SECTION 009113 – ADDENDUM ONE

- A. Project Name: 23087 Clinton Reroofing Project
- B. Owner: Clinton Public School District, 201 Easthaven Drive, Clinton, MS 39060.
- C. Architect: Dale | Bailey, an Association, One Jackson Place, Suite 250, 188 East Capitol Street, Jackson, MS 39201.
- D. Architect Project Number: 23087
- E. Date of Addendum One: 16 February 2024

23087 Clinton Reroof Project / Pre-Bid Meeting

AS-1

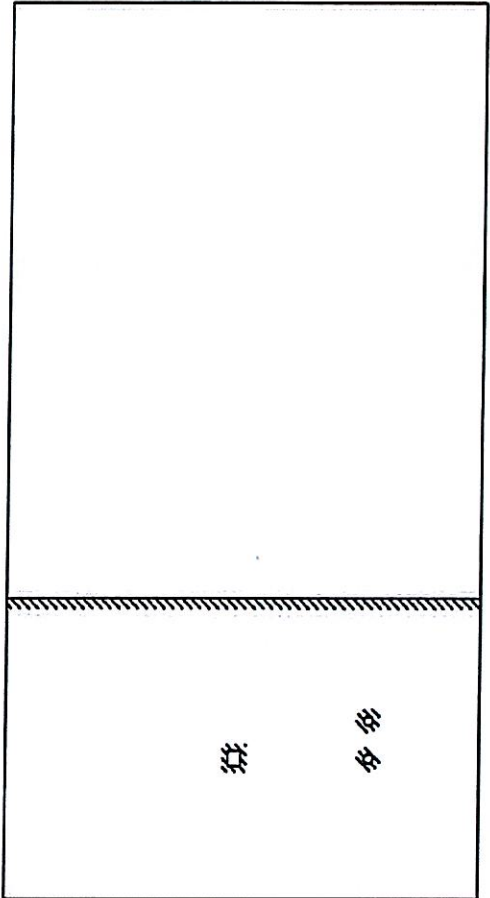
Remove all ACM roof wall and penetration flashing coating out 12 inches from the edge and down to the deck in the locations shown on attached drawing AS-1. Penetration include heater flues, plumbing vents, exhaust fans, etc. Coordinate work with roofing contractor so that replacement materials are installed same day as abatement of ACM roofing materials.
